Subject: Supplemental Submission for Baxter Road and Sconset Bluff Storm
Damage Prevention Project (DEP File No. SE 048-2581)

**BAXTER ROAD AND SCONSET BLUFF STORM DAMAGE PREVENTION PROJECT
NOTICE OF INTENT (DEP FILE NO. SE 048-2581)**

**RESPONSES TO QUESTIONS FROM NANTUCKET CONSERVATION COMMISSION ASKED AT
PUBLIC HEARING ON AUGUST 28, 2013**

Figure 1
Barge Delivery Locations and Benthic Habitats

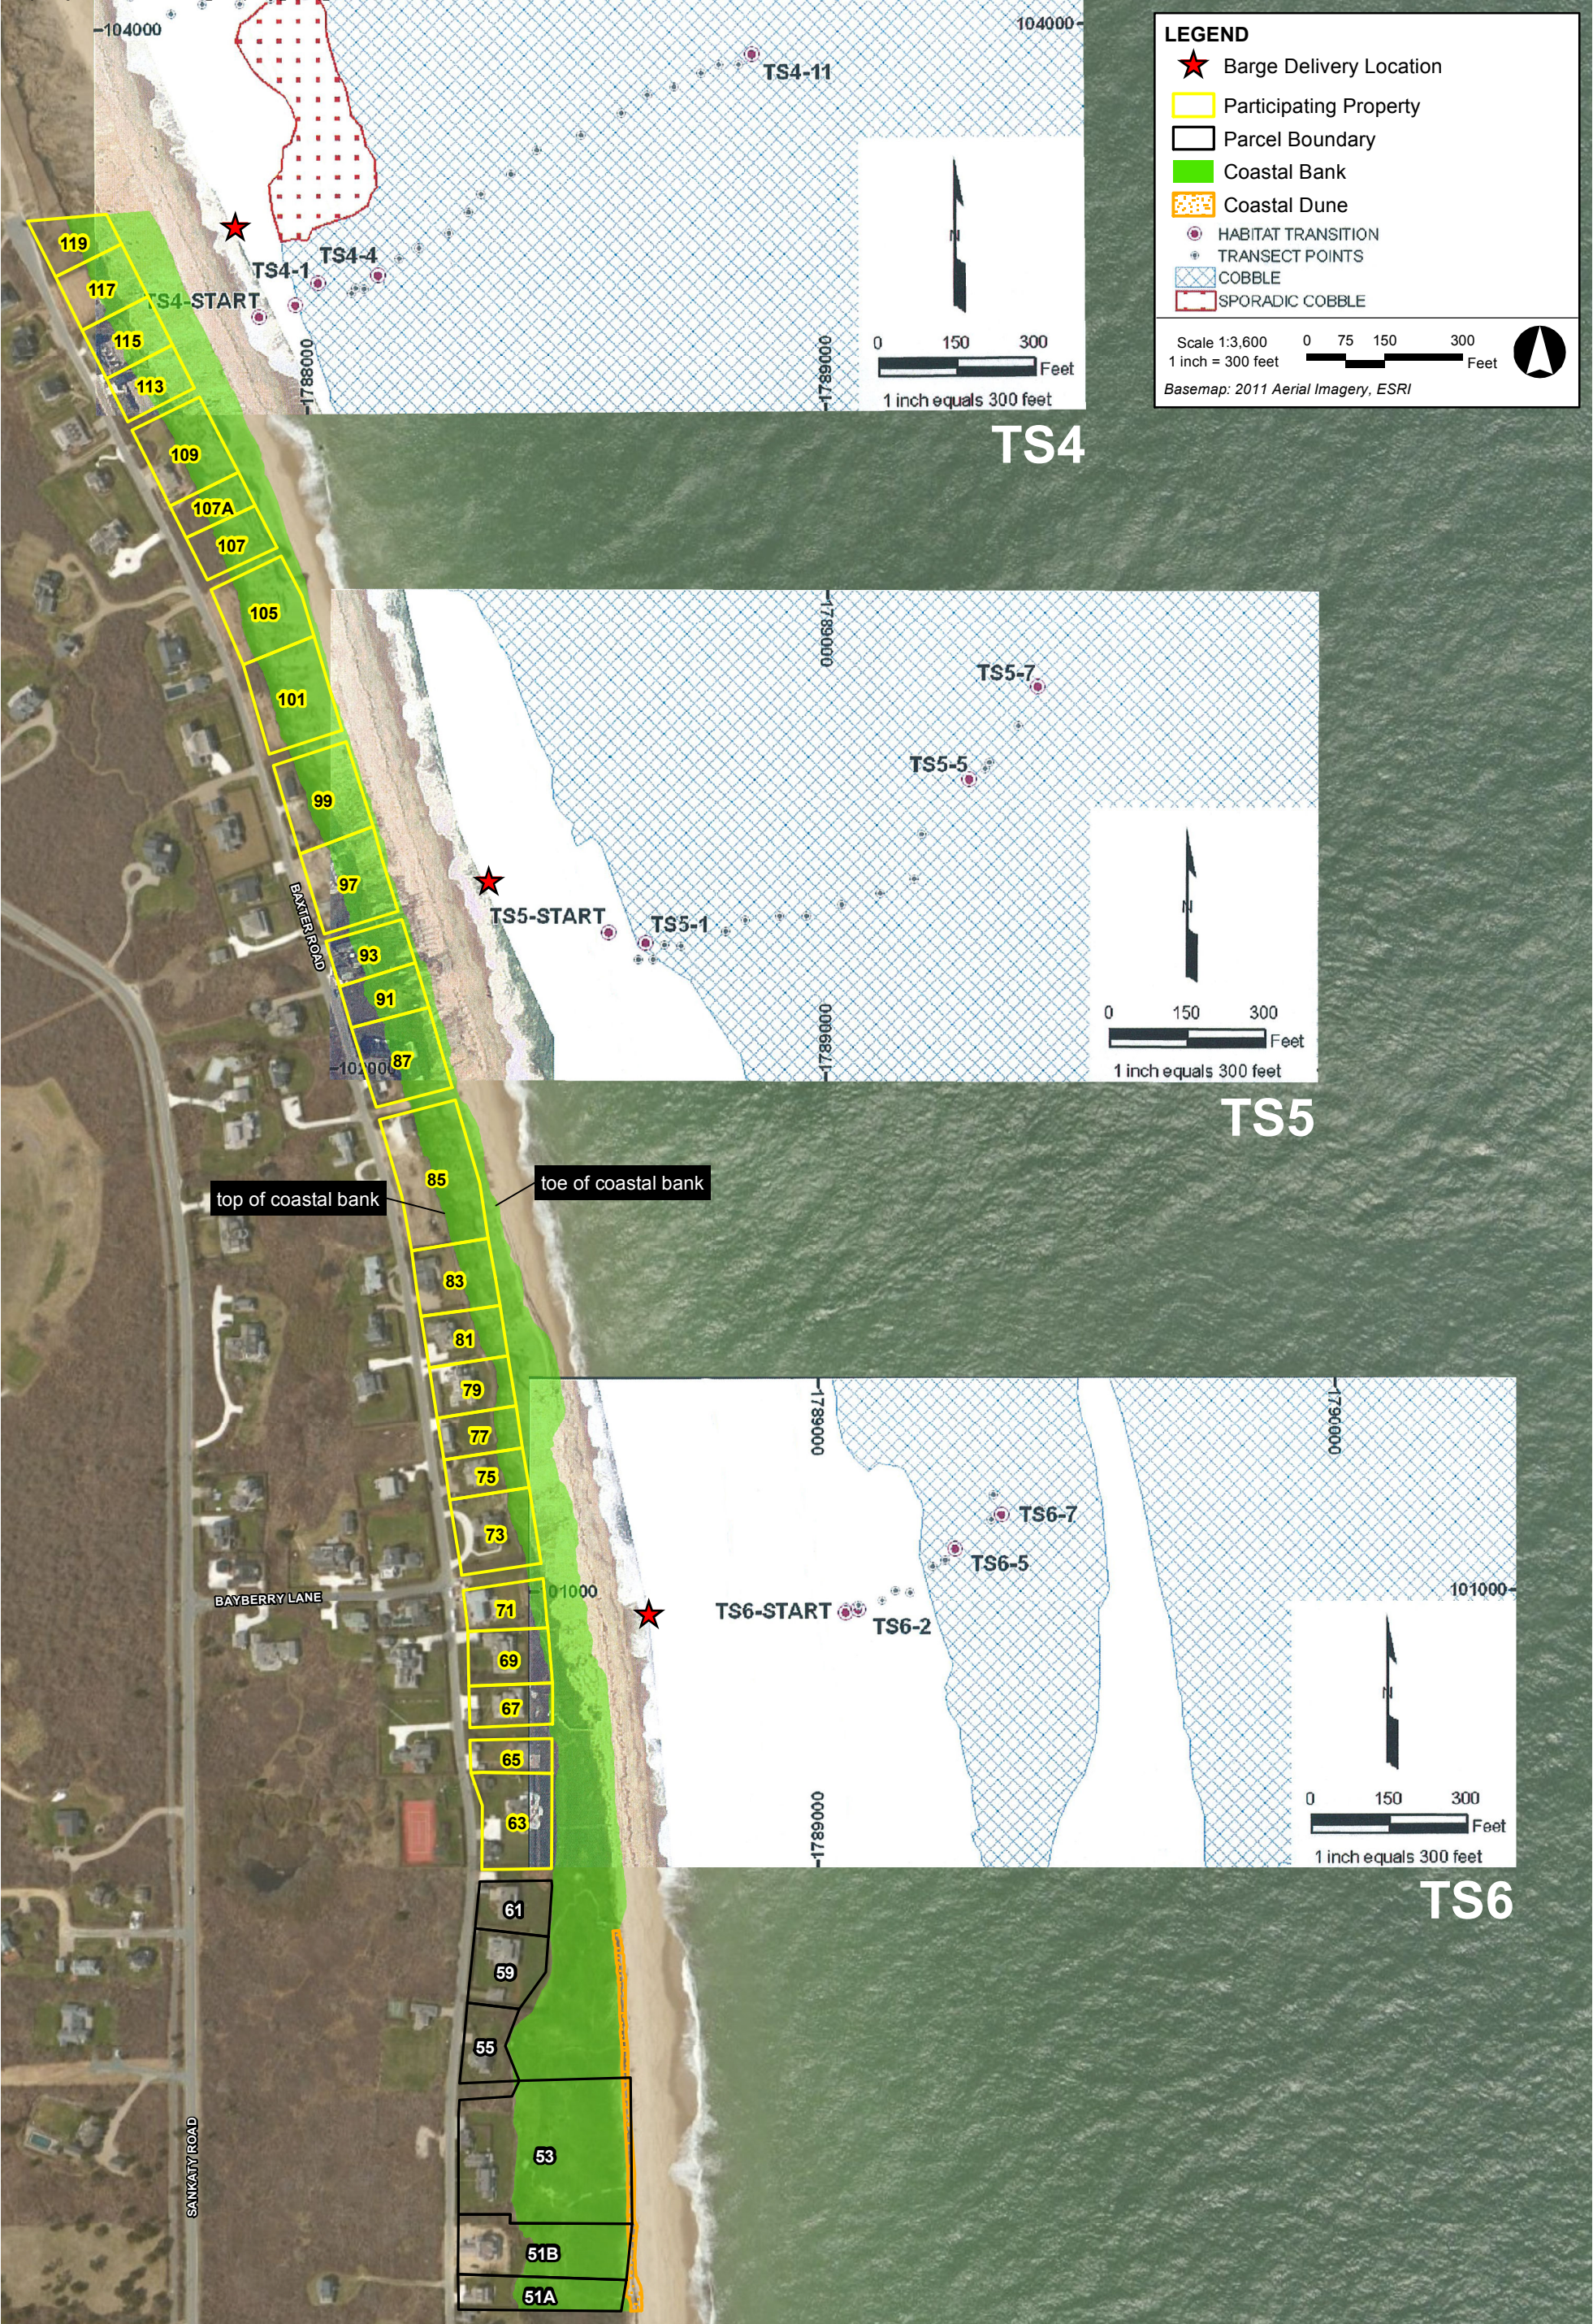
Provide potential barge landing locations.

Figure 1 shows the location of potential barge landings. The barge landings are in the nearshore sandy sediment/benthic zone along the Sconset Beach, which is a very dynamic zone and is not a productive habitat as is the case of the offshore cobble habitat zones.

This figure also includes "Viewport Locations" labeled TS4, TS5 and TS6 which were prepared by Coastal Planning & Engineering (CPE) as part of the benthic community investigations for the proposed Sconset Beach Nourishment Project (see attached report). These "Viewport Locations" represent a combination of (1) high resolution side scan sonar (SSS) investigation of the seafloor to map benthic habitat (including cobble bottom) areas and (2) underwater nearshore transects surveyed via a marine biologist using scuba and underwater videography to record benthic habitats as well as fish species observed. Benthic habitats were grouped into three classifications: sand, sporadic cobble and cobble. The three transects in the revetment project area (TS4, TS5, TS6) have a sand benthic habitat nearest the beach with either sporadic cobble (as in TS4) or cobble habitat progressively seaward. Sand habitat is generally a very dynamic zone with few benthic organisms present. It was determined that cobble habitat located farther offshore may serve as a nursery for juvenile black seabass or other fish species.

Potential barge landing locations have been identified along the beach and in the sand habitat zone. None of the potential barge landing locations are located within cobble habitat and the beaching of the pier barge would not impact cobble habitat or other sensitive habitat areas. Since this sand zone is very dynamic with few benthic species present, potential impacts to benthic habitats by landing a barge along the beach is determined to be negligible.

Figure 1. Plaxis results – Vertical settlements of proposed revetment with sacrificial berm at toe.

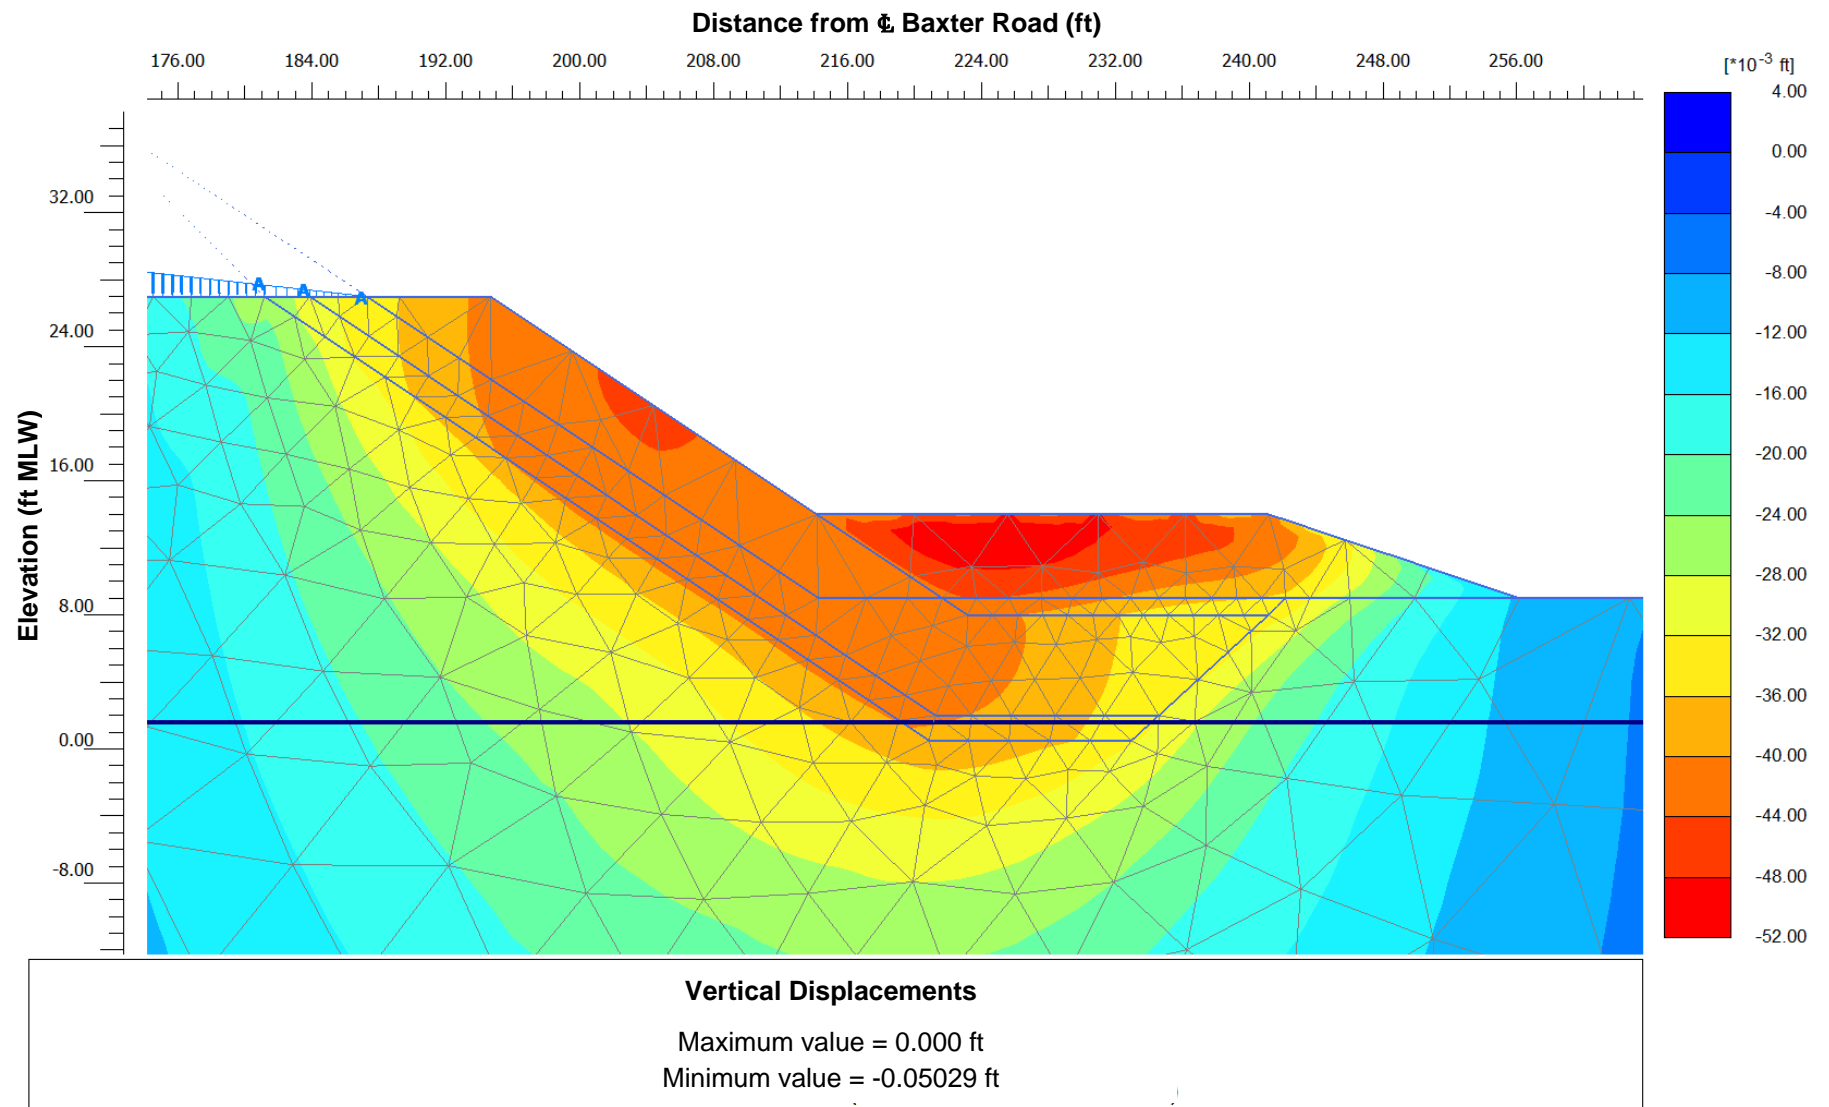
Provide more information on the potential settlement of the revetment when wet or influenced by waves.

Two conditions of the proposed revetment were analyzed in Plaxis: (a) with a sacrificial sand berm at the toe (Figure 1); and (b) without the berm (Figure 2). The maximum potential vertical settlement for both conditions is only about 0.6 inch, which is negligible compared to the amount of sand removed and the revetment material placed and unlikely to affect the function of the proposed revetment. Note that more vertical settlements could be expected if weaker soils are actually found within the assumed extent of coastal beach sand.
